OIL - REPLACE THE CLIPPING BRACKETS ON THE OIL TANK AT CP0787 AND CP0788 - CATEGORY
CODE 3 - MOD.ENG-79-0004

- (1) Aircraft: Airbus A320
- (2) Engine: V2500-A1 Engine, Serial No.'s V0014 through V0039

V2500-ENG-79-0004

Location of the clipping brackets at CP0787 and CP0788
Fig.1

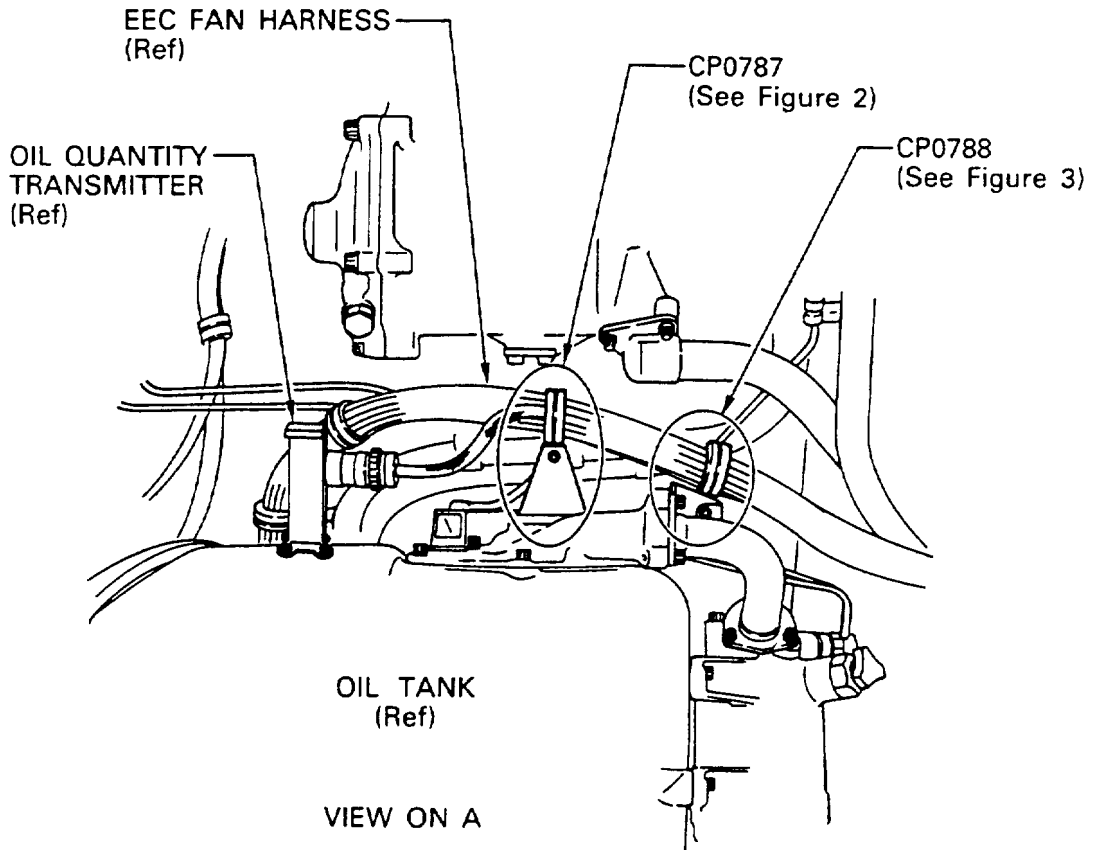
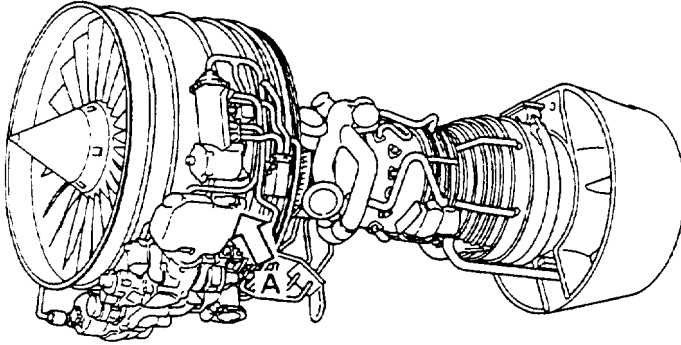
Chaffing of the EEC Fan Harness may occur because of the excessive vibration of the EEC Fan Harness, which is held by the Clipping Brackets at CP0787 and CP0788 where the EEC Fan Harness is routed close to the Oil Quantity Transmitter on the Oil Tank.

The cause for the problem is the insufficiency of rigidity of the Clipping Brackets, which permit the excessive movement of the Harness due to resonances.

- (1) The changes introduced by this Service Bulletin are as follows: (See Figures 1 and 2.).
 - (a) Two gussets are welded to each new Clipping Bracket, of which stock thickness is also changed from 0.047in. (1,2 mm.) to 0.063in. (1,6 mm.) to increase the rigidity of each Clipping Bracket at CP0787 and CP0788.
 - (b) At CP0787, the clip Bolt is changed to use a new longer Bolt to accomodate with the new thicker Bracket.
- (2) The existing Clipping Brackets at CP0787 and CP0788 must be replaced with the new Brackets.
- (3) New Clipping Brackets will be available for replacement purposes.

Replacement of the clipping brackets at CP0787
Fig.2

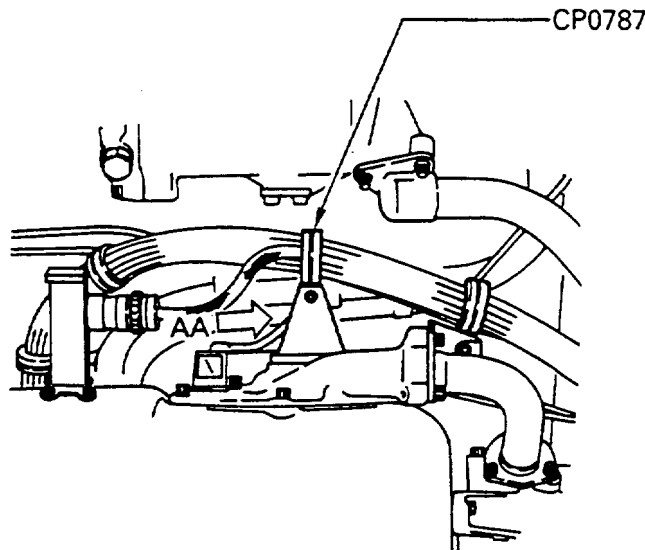
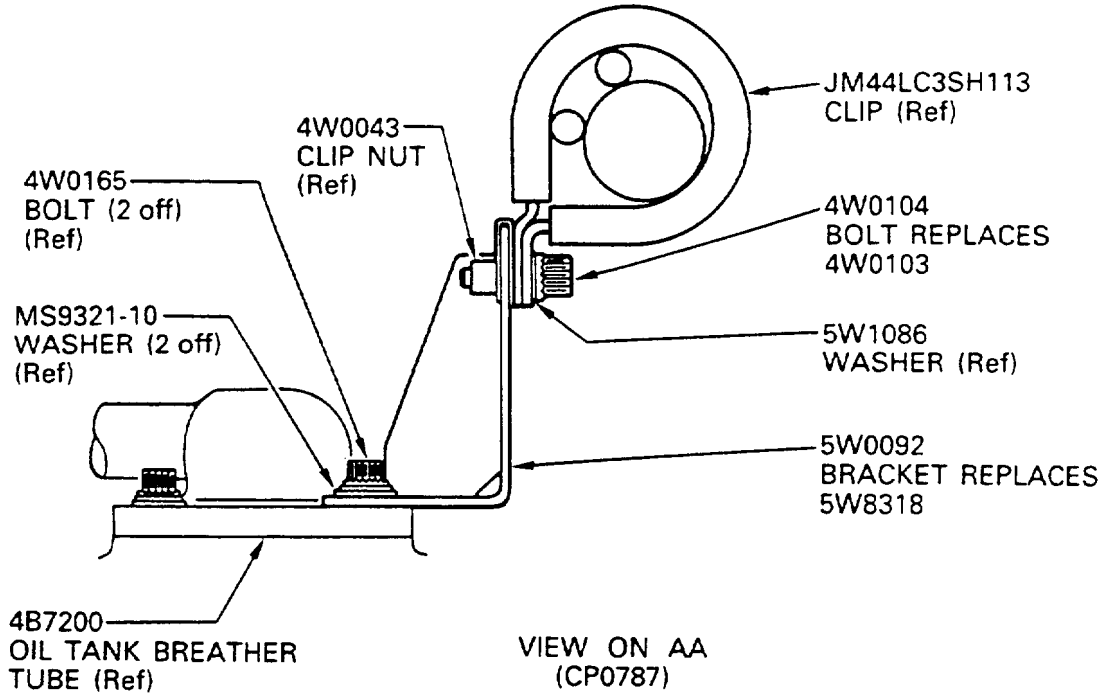
- (1) At CP0787, replace PN 5W8318, Clipping Bracket, on the Oil Tank Breather Tube, with new PN 5W0092, Clipping Bracket as follows: (See Figures 1 and 2).

- (a) Remove PN 4W0103, Bolt, and PN 5W1086, Washer, which attach PN JM44LC3SH113, Clip to PN 5W8318, Clipping Bracket.
 - (b) Remove two PN 4W0165, Bolts and PN MS9321-10, Washers which attach PN 5W8318, Clipping Bracket, to PN 4B7200, Oil Tank Breather Tube flange.

- (c) Remove 5W8318, Clipping Bracket, and remove PN 4W003, Clipnut.
 - (d) Attach new PN 5W0092, Clipping Bracket, to PN 4B7200, Oil Tank Breather Tube flange with two PN 4W0165, Bolts and PN MS9321-10, Washers. Torque the Bolts to 85 to 105 lbfin (10 to 12 Nm).

- (e) Attach PN 4W0043, Clipnut to PN 5W0092, Clipping Bracket.
 - (f) Attach PN JM44LC3SH113, Clip to PN5W0092, Clipping Bracket, with new PN 4W0104, Bolt and PN 5W1086, Washer. Torque the Bolt to 36 to 45 lbfin (4,00 to 5,00 Nm).

Replacement of the clipping bracket at CP0788
Fig.3

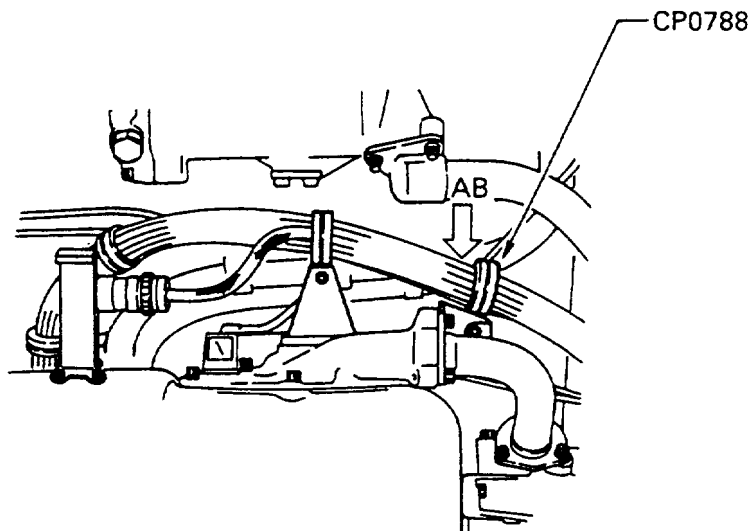
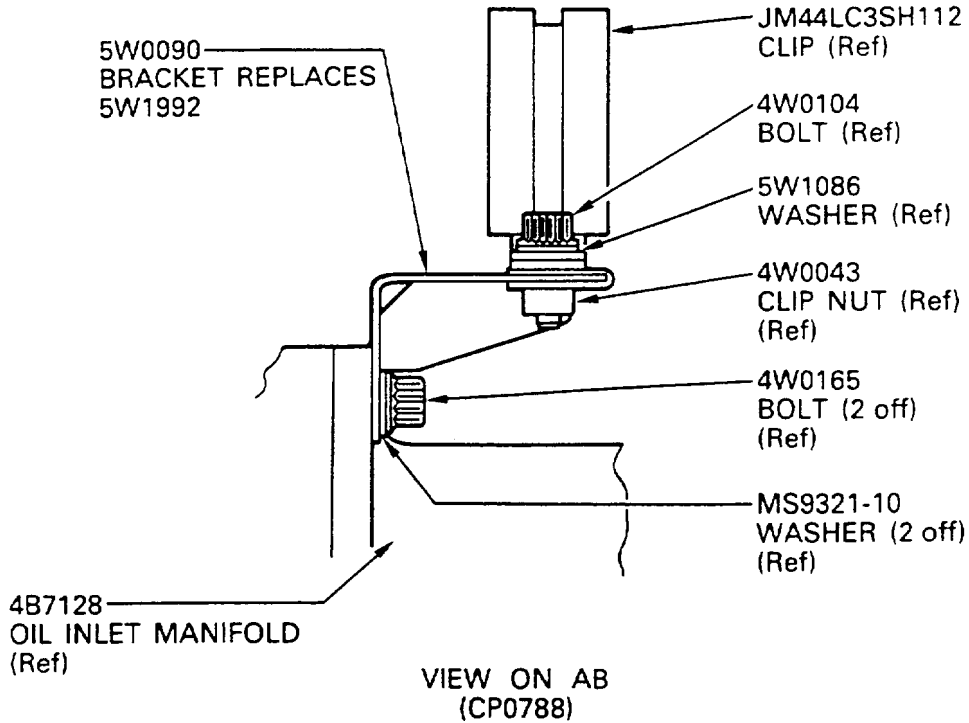
- (2) At CP0788, replace PN 5W1992, Clipping Bracket, on the Oil Inlet Manifold, with new PN 5W0090, Clipping Bracket as follows: (See Figures 1 and 3).

- (a) Remove PN 4W0104 Bolt, and PN 5W1086, Washer, which attach PN JM44LC3SH112, Clip to PN 5W1992, Clipping Bracket.
 - (b) Remove two PN 4W0165, Bolts and PN MS9321010, Washers which attach PN 5W1992, Clipping Bracket, to PN 4B7128, Oil Inlet Manifold flange.

- (c) Remove PN 5W1992, Clipping Bracket and remove PN 4W0043, Clipnut.
 - (d) Attach new PN 5W0090, Clipping Bracket, to PN 4B7128, Oil Inlet Manifold flange with two PN 4W0165, Bolts and PN MS9321-10, Washers. Torque the Bolts to 85 to 105 lbfin (10 to 12 Nm).

(e) Attach PN 4W0043, Clipnut to PN 5W0090, Clipping Bracket.

(f) Attach PN JM44LC3SH112, Clip to PN 5W0090, Clipping Bracket, with PN 4W0104, Bolt and PN 5W1086, Washer. Torque the Bolt to 36 to 45 lbf·in (4,00 to 5,00 Nm).
